MODIFICATION REQUEST:

**Concept Plan at Shepherds Bay Foreshore,
Meadowbank and Ryde**

MP09_0216 MOD2

Environmental Assessment Report
Section 75W of the *Environmental Planning and
Assessment Act 1979*

Figure 8: Comparison of the approved (left) and proposed modified (right) Stage A building envelope (Source: proponent's application)

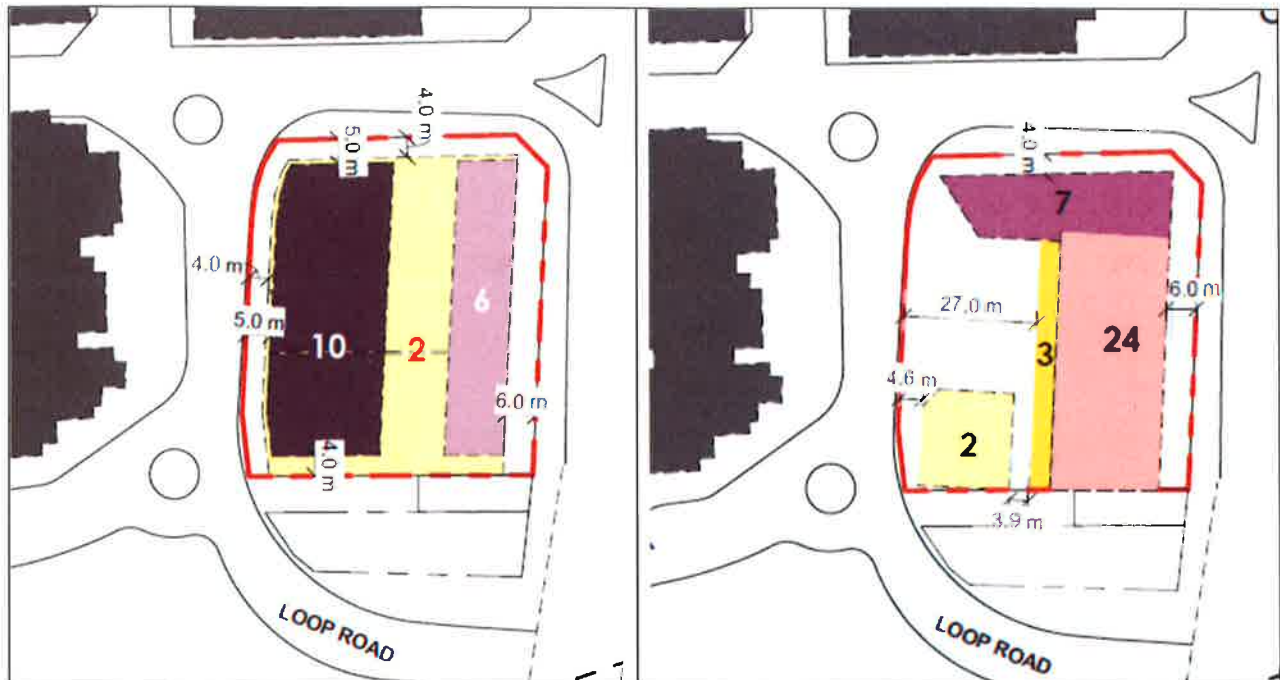
- increase the height of the tower component of Stage A from a maximum of 10 storeys (RL 57.70) to 24 storeys (RL 95.80);
- modify the layout of the building envelope locating the tower component on Church Street and including an open space to the rear; and
- increase the height of lower-scale building envelope from six to seven storeys.

The Department does not accept the proposed 24-storey height is appropriate given this height will result in a completely estranged scale and height relationship with nearby and adjoining development. In particular, the Department notes the proposed height would be approximately six times the height of any development allowed (under the Ryde LEP 2014) along Church Street, over three times the height of the up to seven storey buildings to the north and west, and over two times the height of the highest components of the remainder of the Concept Plan site. In this context the proposed development is fundamentally contrary to Planning Principle no.1 as it would appear particularly incongruous, isolated, and would visually dominate the skyline at local, distant and river views.

The Department therefore recommends a modification requiring the Stage A building envelope be reduced by nine storeys in height (from 24 to 15 storeys). The Department notes the competition winning scheme included beneficial urban design outcomes, including a public plaza and reconfigured building envelope layouts when compared to the original Concept Plan. Therefore, to ensure these benefits are not discouraged, design excellence is not stifled and the best overall outcome can be achieved, the Department recommends a maximum 15-storey height limit and provide the proponent with the opportunity to recast the scheme to achieve this height.

Figure 16: Building envelope massing, indicating 10-, 15- and 24-storey heights (Base source: proponent's application)

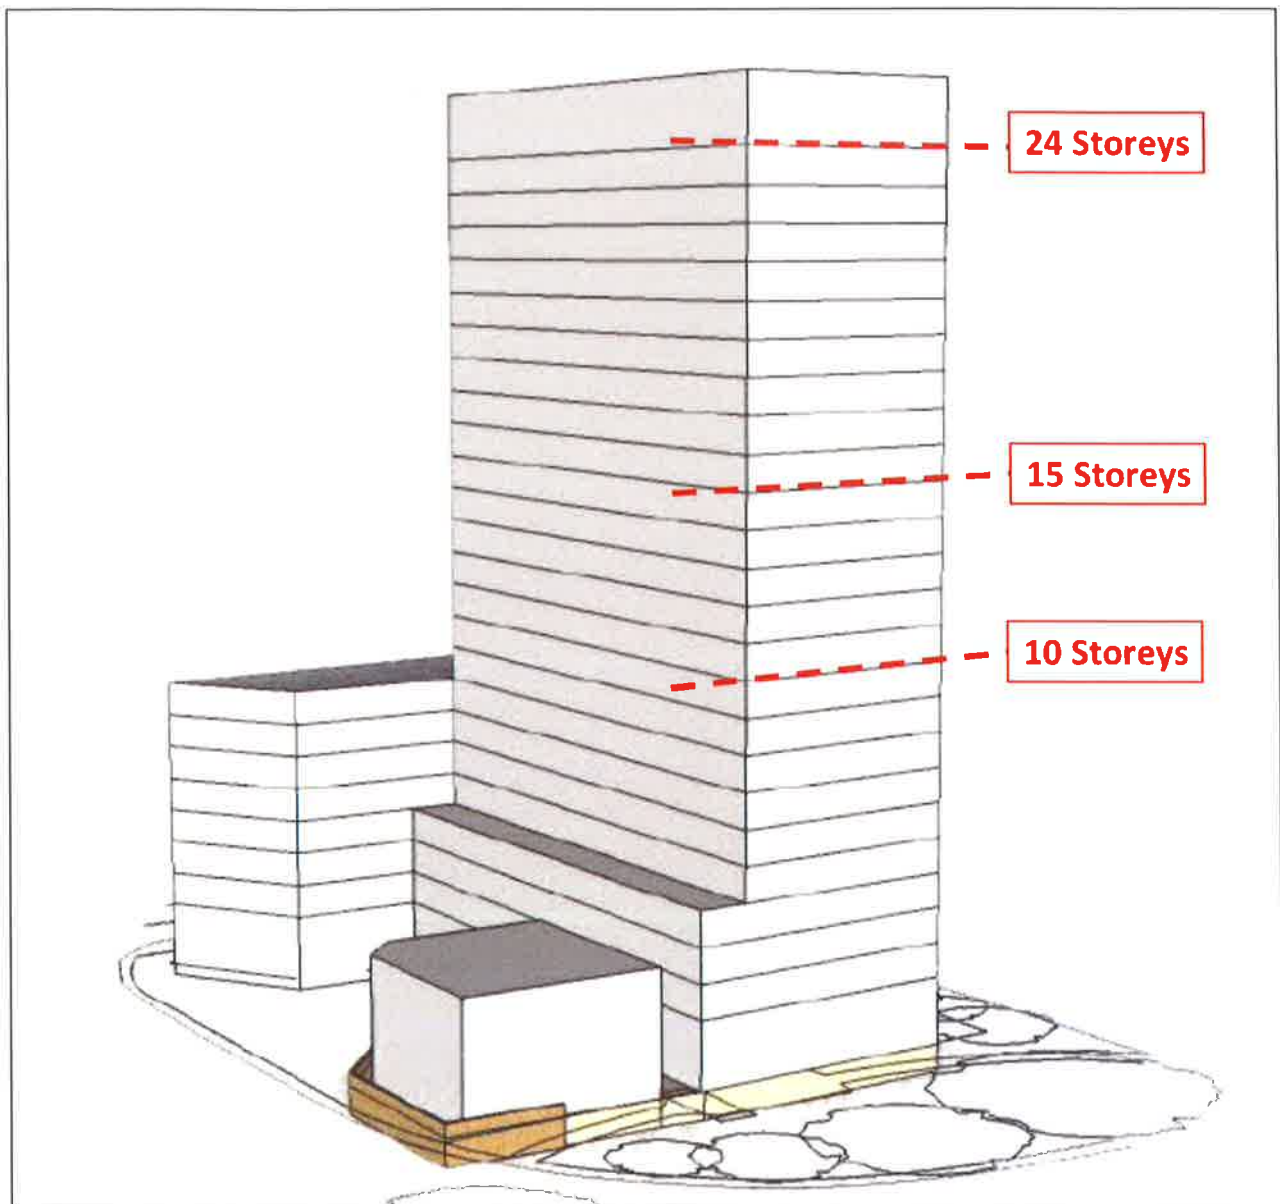
The Department considers the proposed increase in height fails to address Planning Principle no.1 as set out in the LEC Case. The Department notes in particular (refer to **Figure 16**):

Having regard to the above, the Department maintains its original view that a 15-storey height should reasonably apply to the site, as a maximum. Whilst this height remains significantly taller than the nearby up to seven storey buildings, it retains a scale relationship with the wider Shepherds Bay Concept Plan and will allow the site to substantially fulfil its gateway properties without resulting in the significant adverse impacts as discussed above.

The Department considers a 15-storey height addresses Planning Principle no.1 as it would facilitate the provision of a building that provides a marker for the site while having an appropriate relationship to the immediate surrounding area. Such a height is also considered consistent with what may be reasonably expected under the Concept Approval height controls.

Figure 17: Indicative overshadowing impacts of the Stage A building, with overshadowing from the approved building in red, design excellence building in orange and proposed building in yellow (Source: proponents response to exhibition of the PPR)

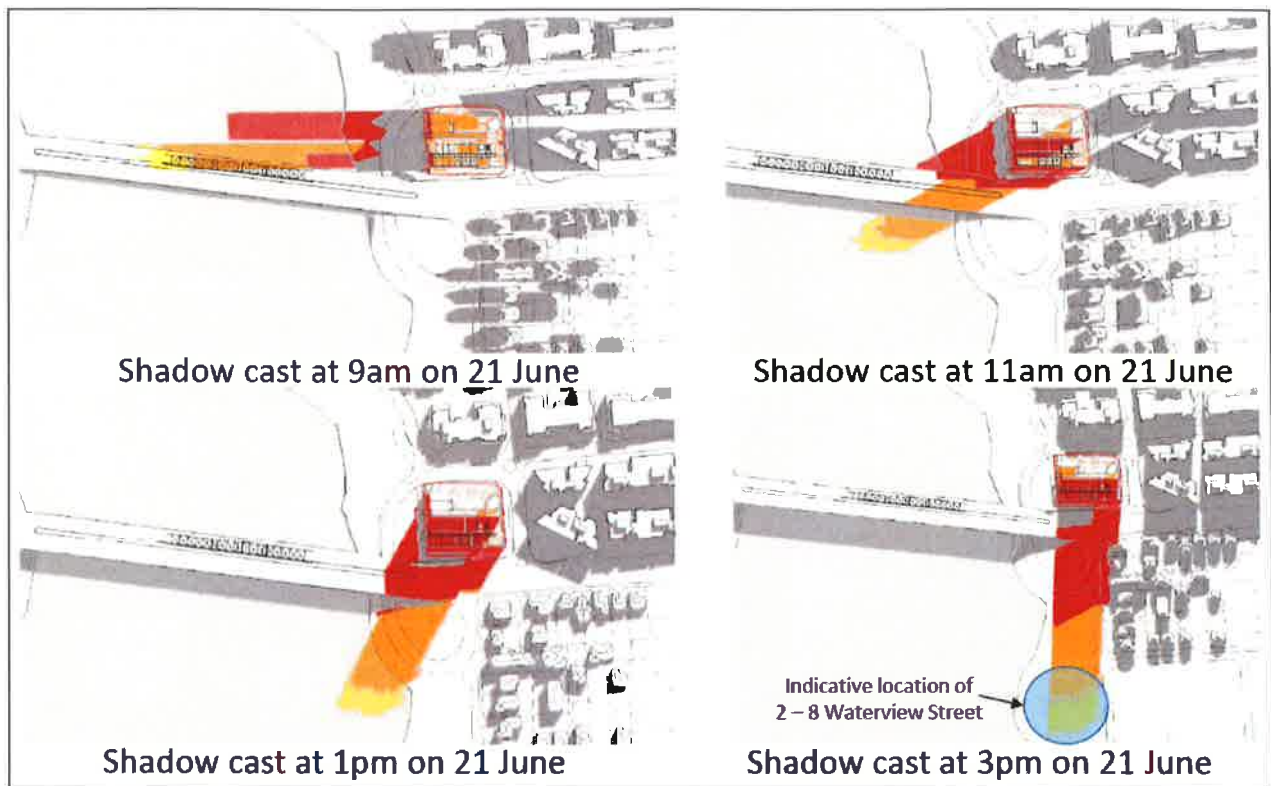
The Department notes that Council and public submissions have raised concerns about potential overshadowing impacts of the Stage A building envelope on properties on Waterview Street.

The Department has carefully considered concerns raised in submissions and the proponent's shadow analysis, and is satisfied that any overshadowing impacts as a result of the proposal on surrounding properties are reasonable for the following reasons:

Figure 18: Approved (left) and proposed (right) Stage 2 and 3 building envelope storey height plan (Base source: proponent's application)

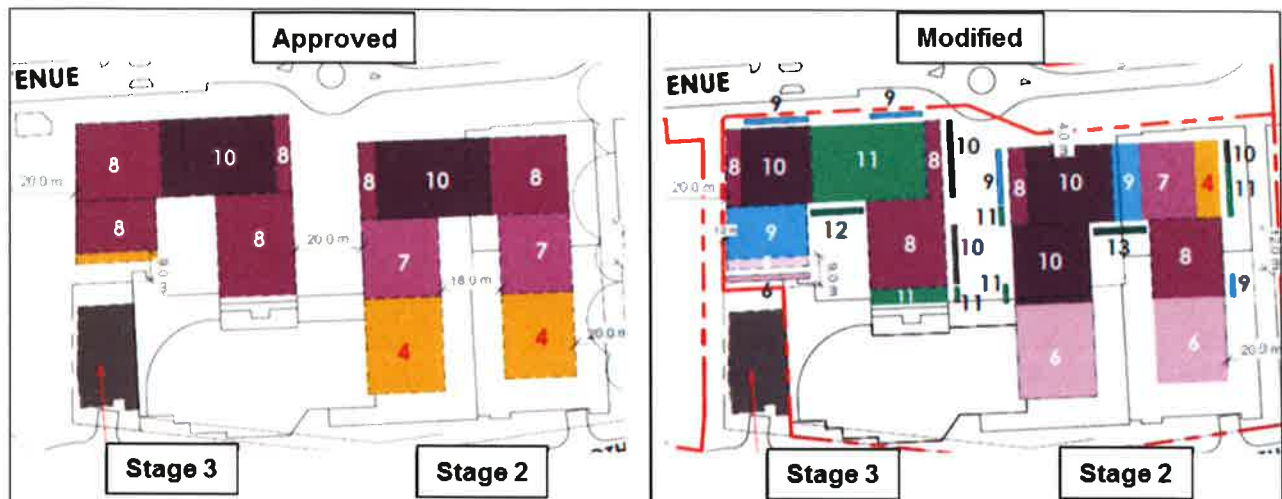
The modification seeks approval for varied increases in the number of storeys contained within the approved building envelopes of Stages 2 and 3 (i.e. no increase in overall building envelope height) and deletion of FEAR 3A. A comparison between the approved and proposed storey height plan is provided at **Figure 18**.

The Department agrees, as the revised storey height plan takes account of elevations at steeply sloping locations, the exception within FEAR 3A allowing for an additional storey is no longer necessary and can be deleted. However, the Department considers it important that future developments continue to be required to comply with the approved storey height plan and therefore this part of the FEAR is retained.

Figure 19: Approved (left) and proposed (right) Stage 2 building envelope height (Source: proponent's application)

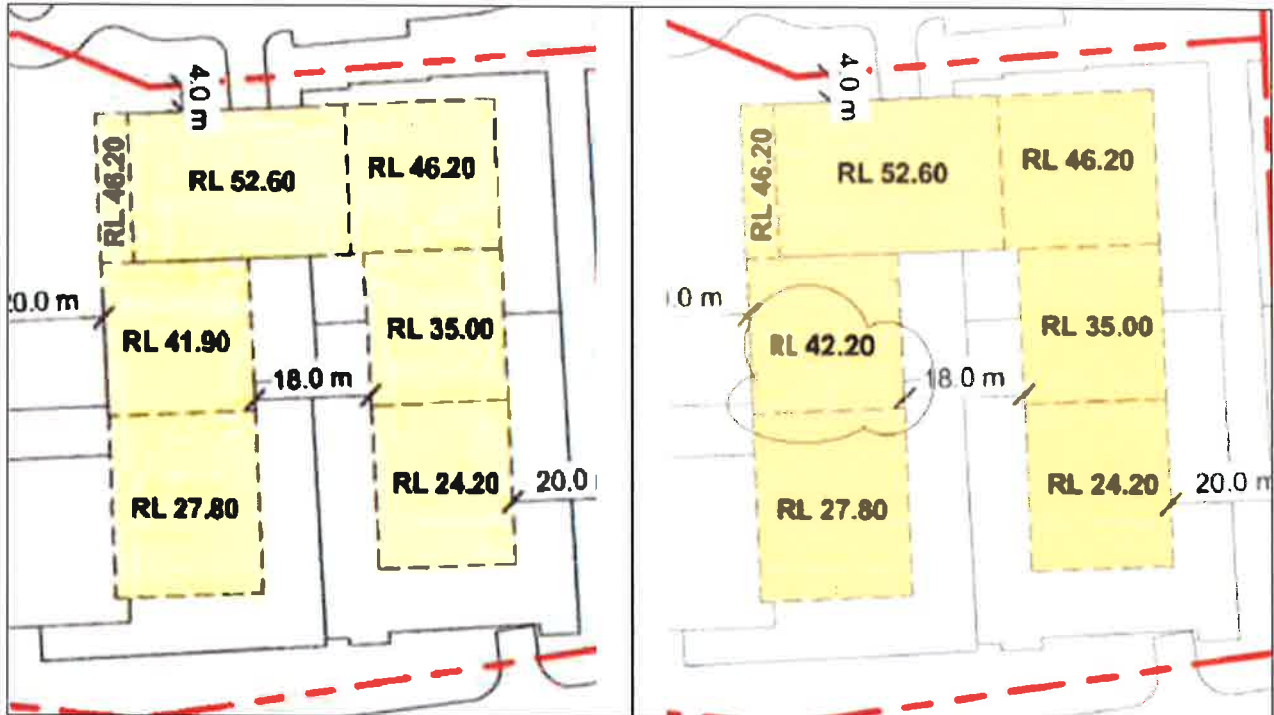
The modification proposes a localised increase the height of part of the western arm of Stage 2 by 300mm (from RL 41.90 to RL 42.20) as shown at **Figure 19**.

The proponent has stated this increase is to facilitate the provision of appropriate floor to ceiling heights in this part of the building.
